Botley West Solar Farm

Change Request 2: Change Report

September 2025

PINS Ref: EN010147

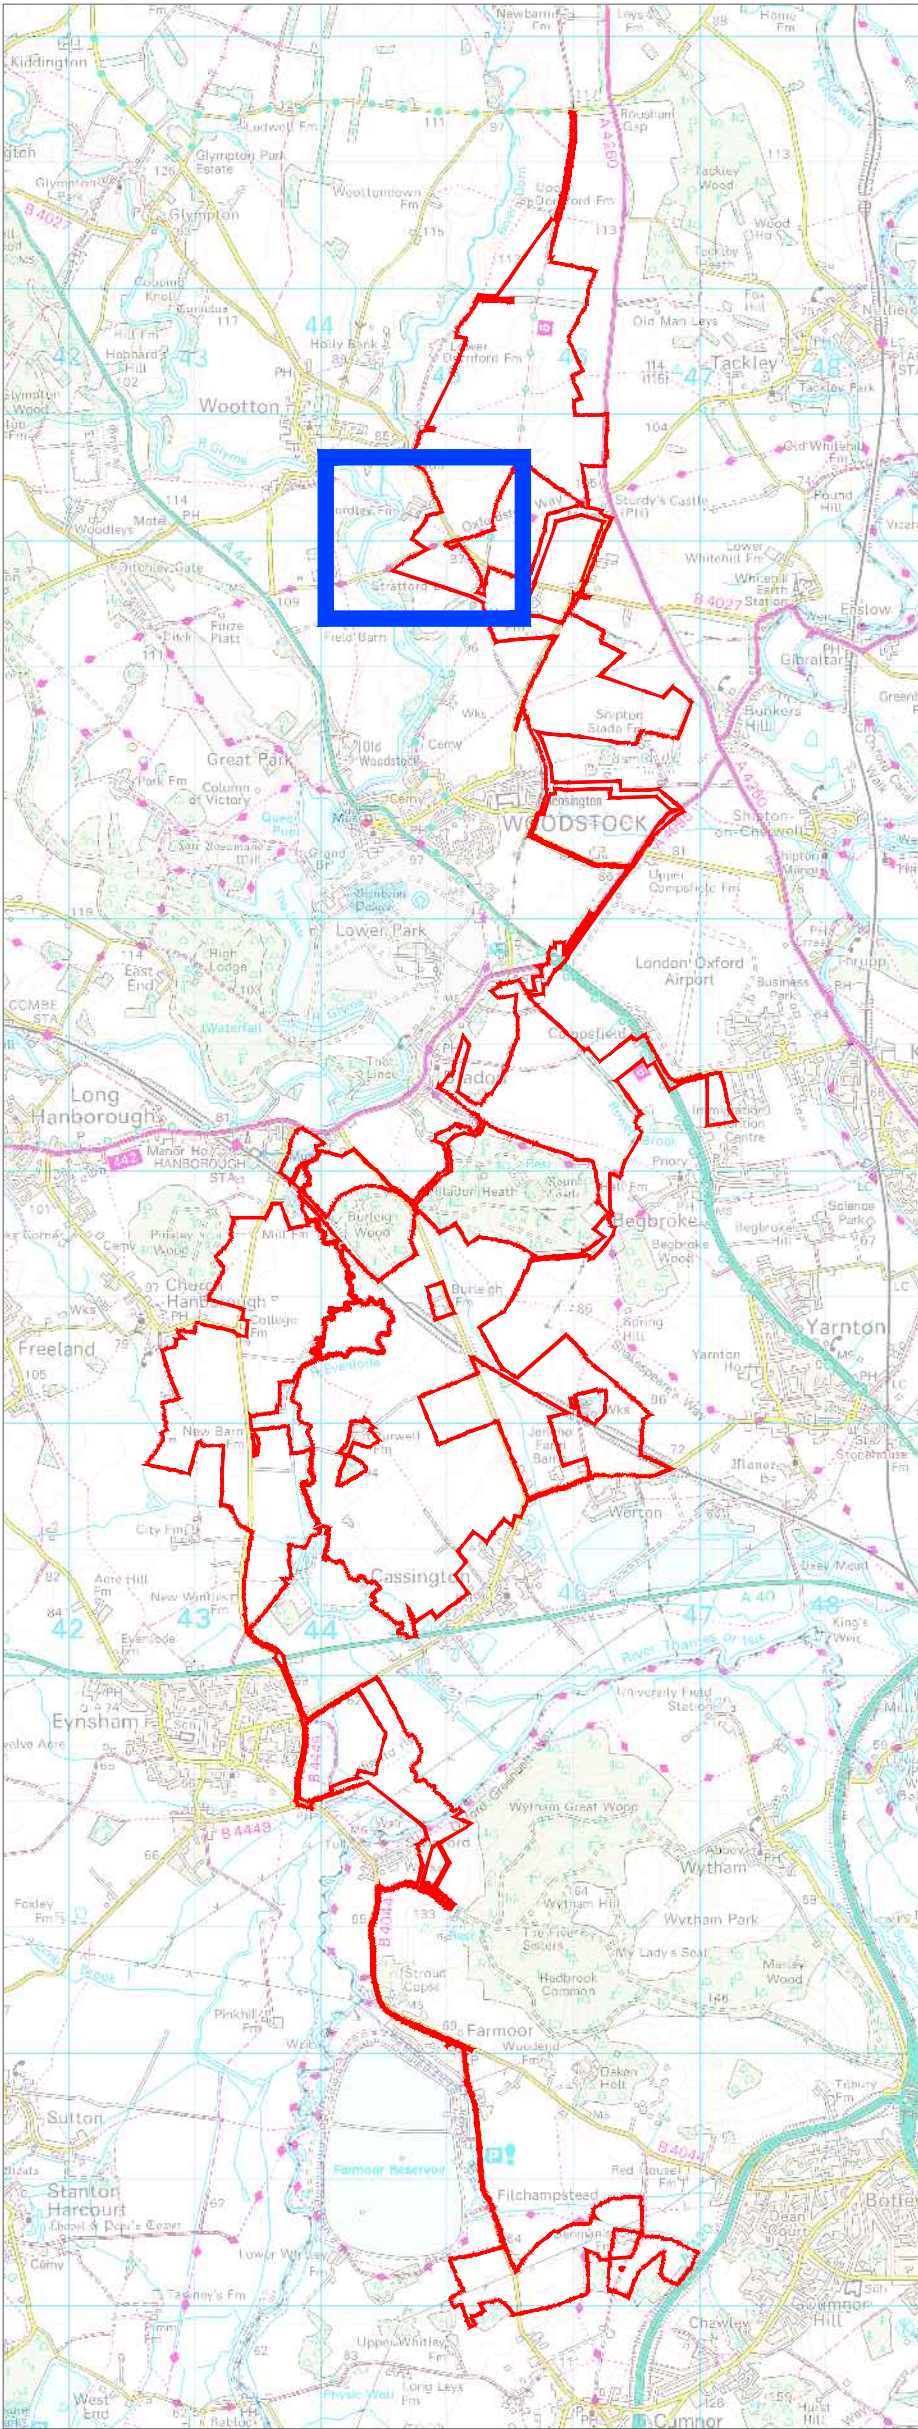
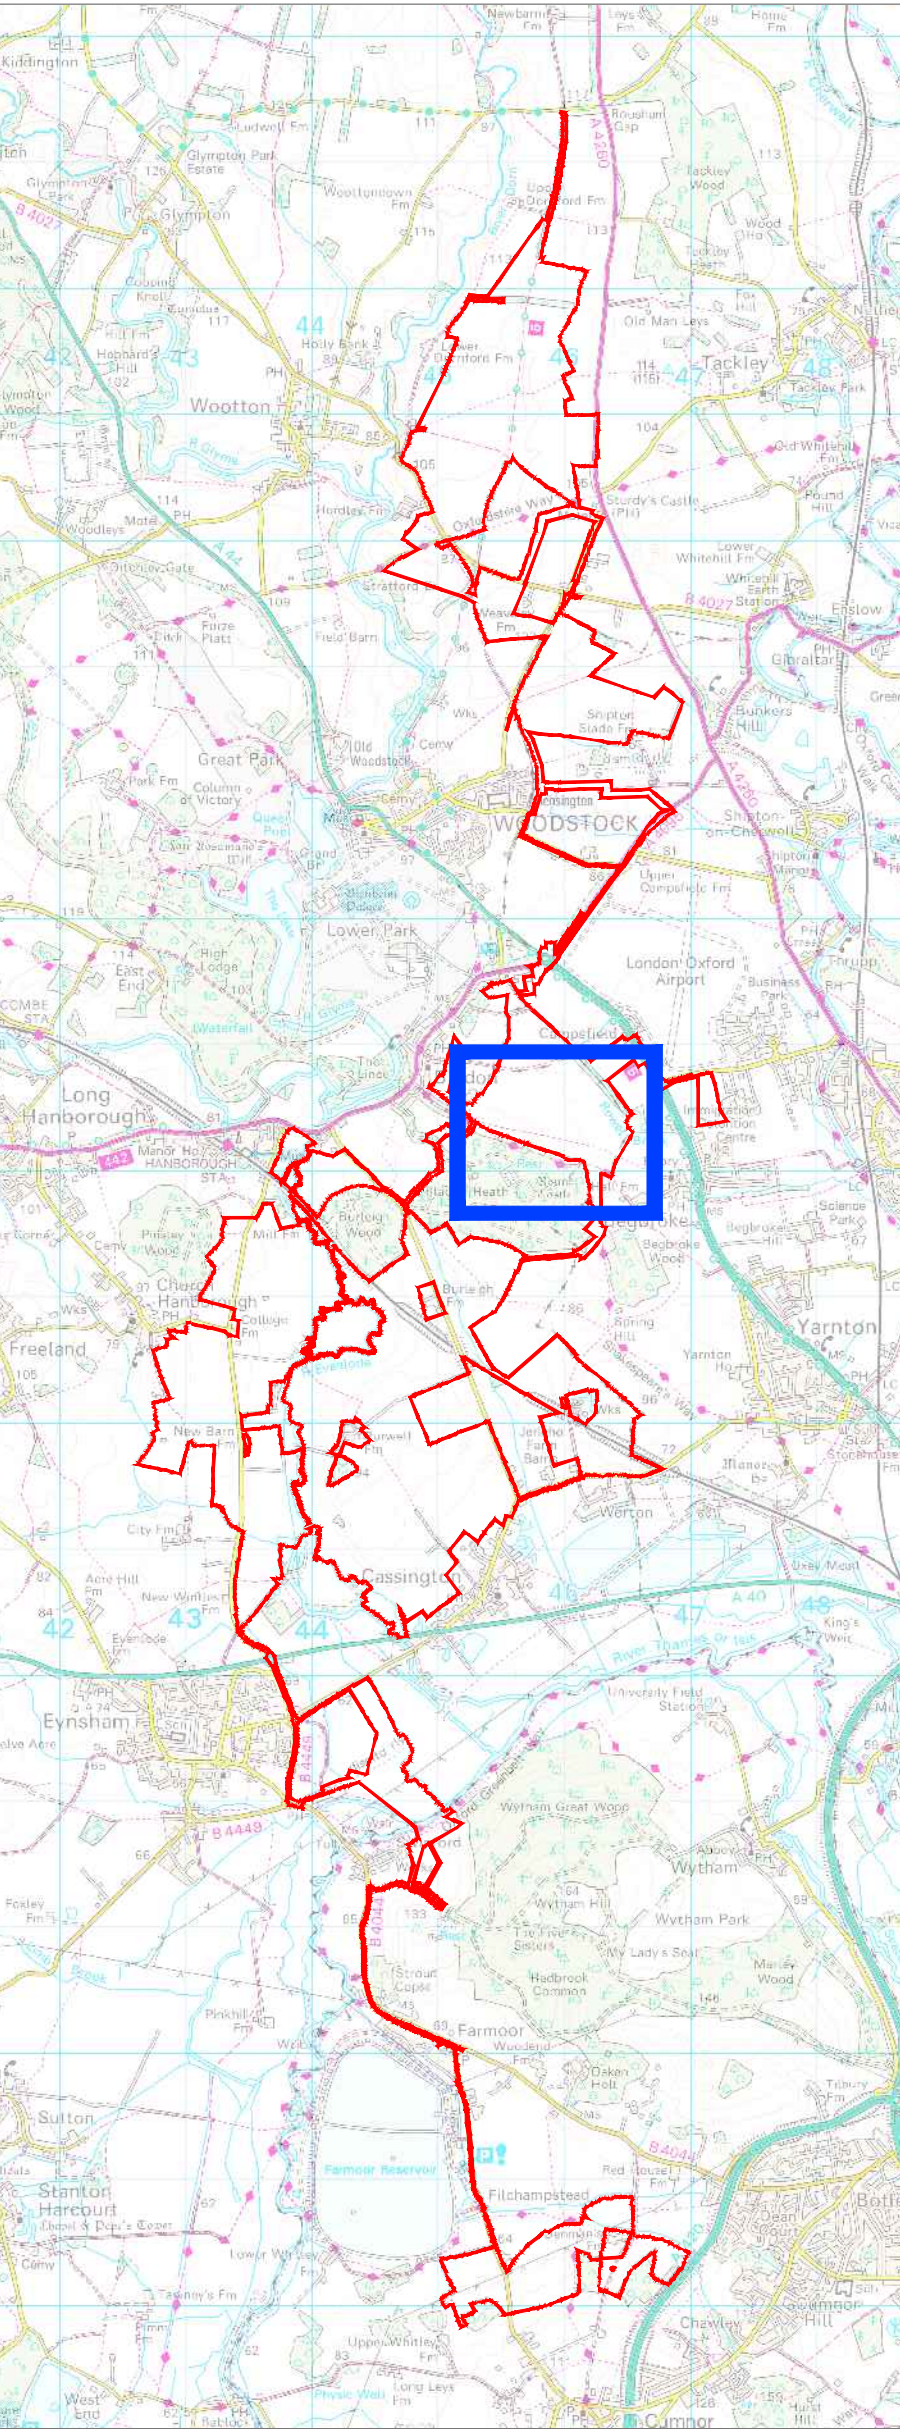
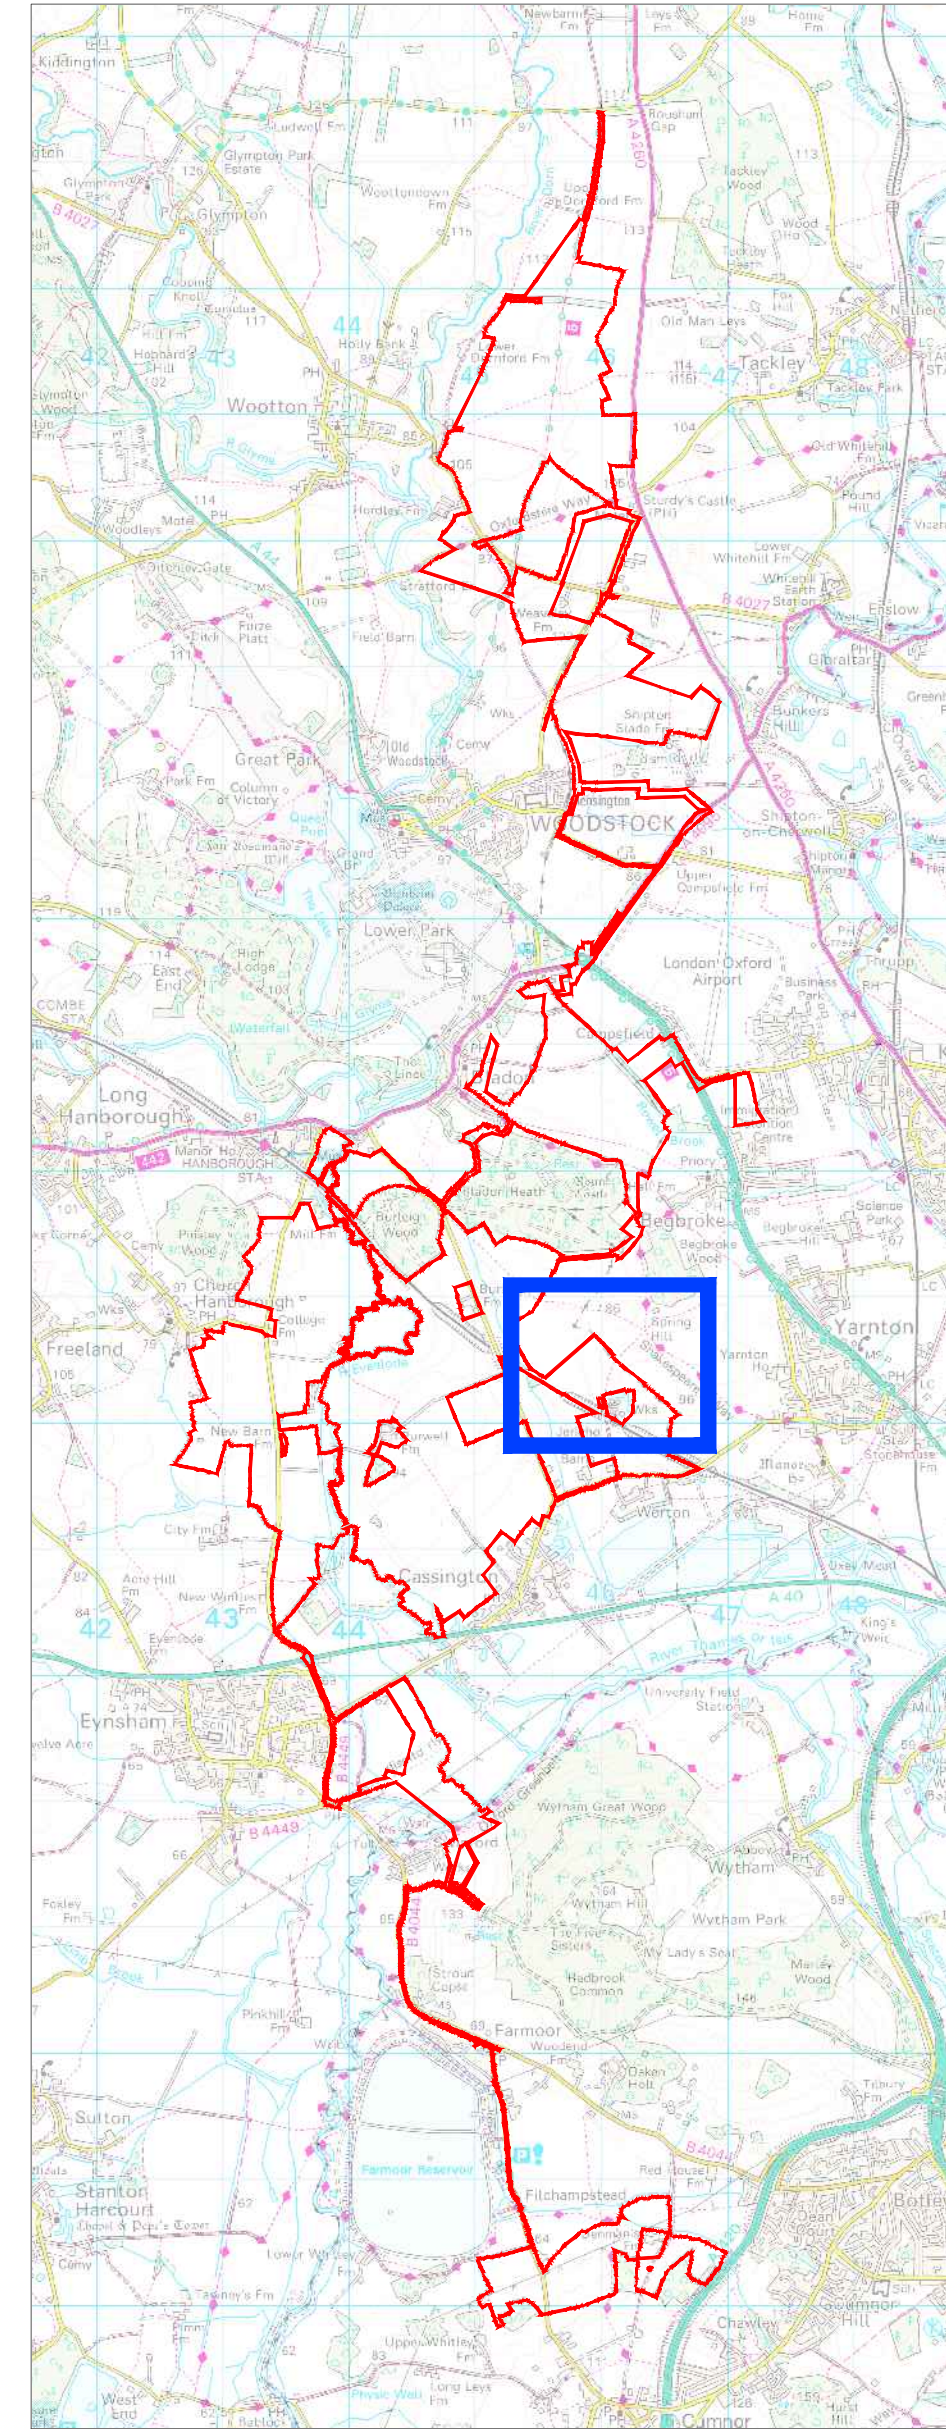
- 2.11.1 Prior to submission of the Applicant's DCO Application, the Applicant became aware that there was a difference between the aerial data showing the used footpath routes on the ground and the Oxfordshire County Council (OCC) definitive data set of their alignment. The data showed that the routes used by the public deviated from the definitive data set alignment. The Applicant therefore sought powers to alter the alignment of the PRow to reflect the 'desire lines' on the ground. However, following ongoing discussions with OCC, the Applicant is seeking to remove those powers to adopt the OCC definitive alignments which will result in a change to the submitted plans.

- 2.11.2 Upon further review of the changes and in light of ongoing consultation, the Applicant also proposes to delete the diversion of the Oxford greenbelt way in addition to the three public footpaths (416/24/10, 132/4/10, 152/8/10), on the basis that the latest datasets that were accessed by the Applicant's GIS team showed an alignment for the Greenbelt Way which does not align with the descriptions and mapping of Oxfordshire County Council. This change is to therefore align with that description/mapping. There is no consequential impact on the solar installation layout or Order Limits as a result of the withdrawal of this proposed permanent stopping up and diversion of the Oxford Greenbelt way.

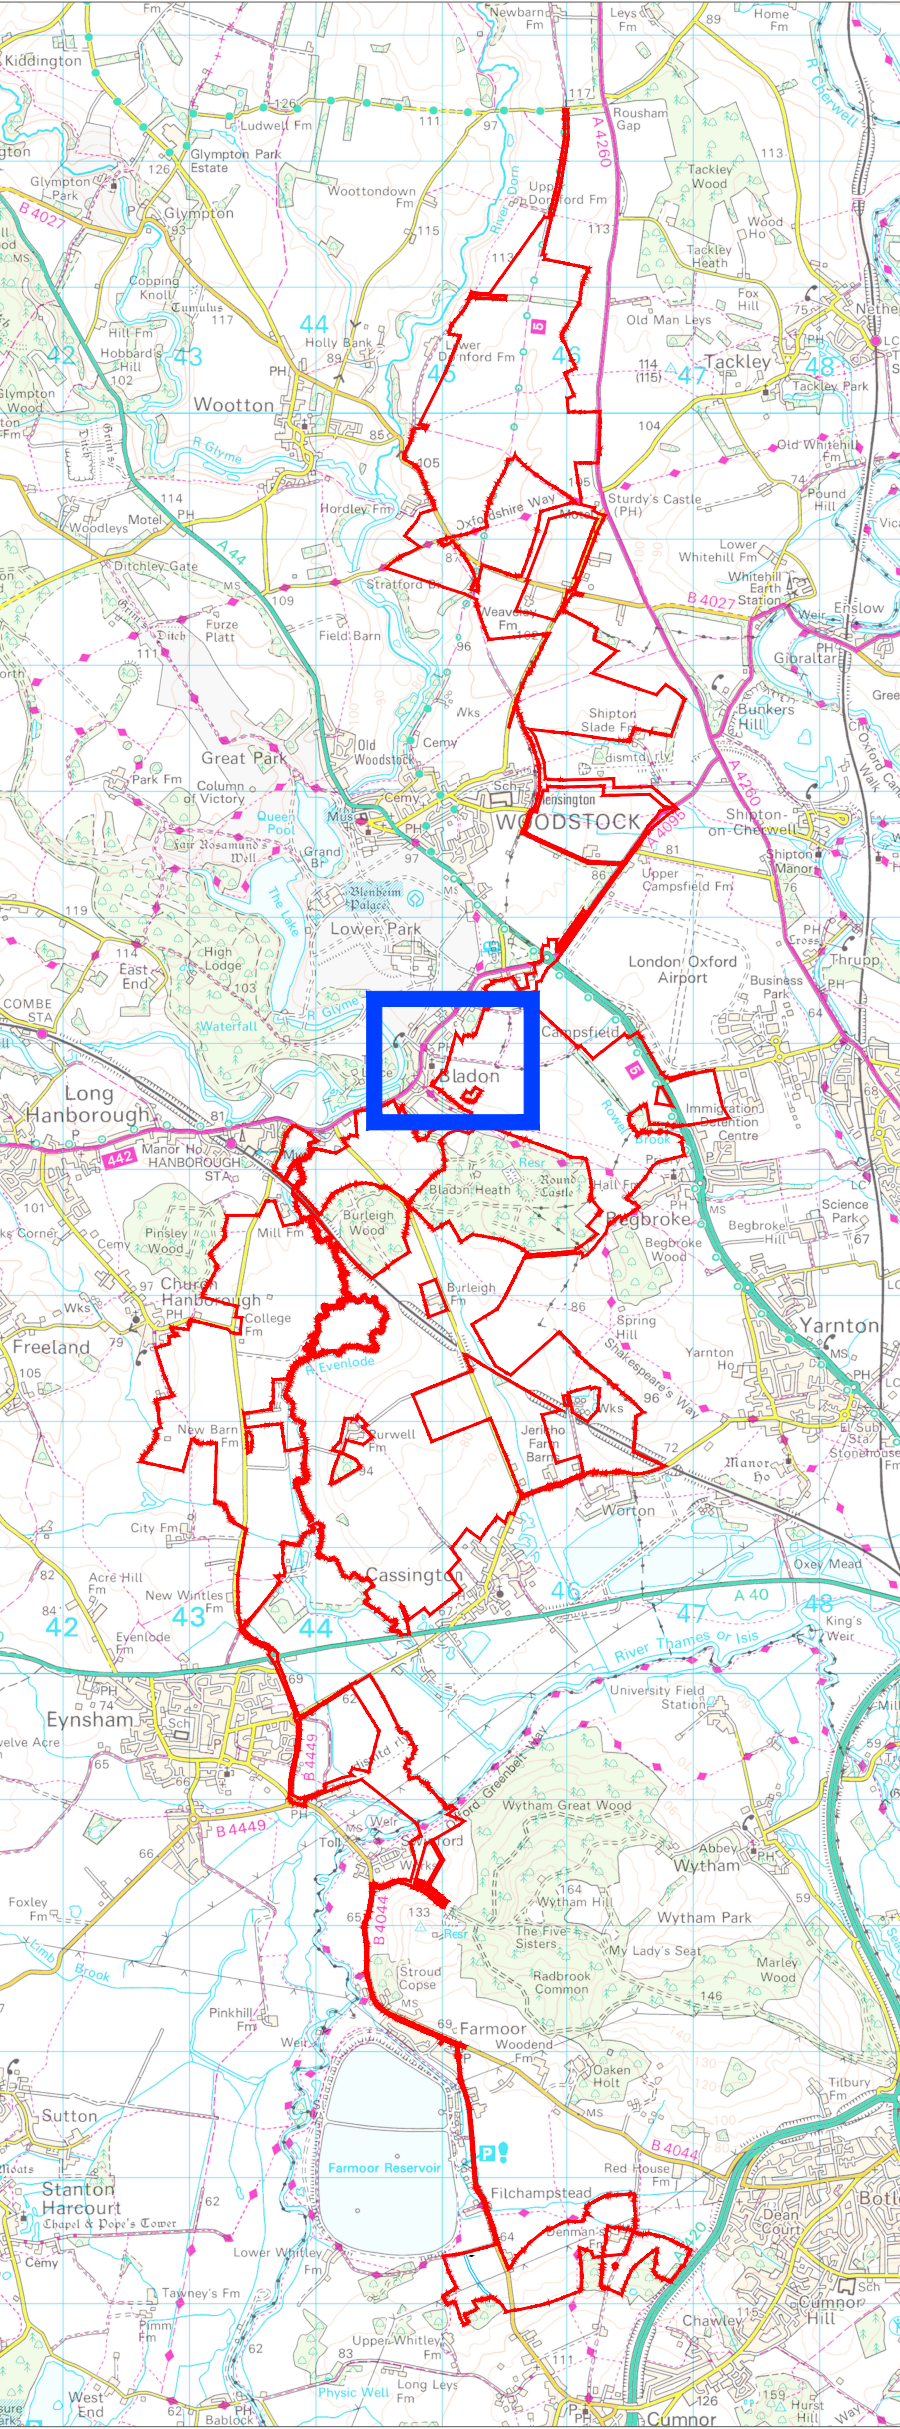
- 2.13.4 In light of the above, the Applicant proposes to remove the education facility from the project and the use the land shown for that purpose (1.15ha) for BNG and other ecology mitigation measures. Chapter 16 and the oOMP have been updated to remove reference to this facility.

(1) Removal of the community educational facility and replacing the land formerly allocated for that use to use for BNG and other ecology mitigation purposes (1,15 Ha)
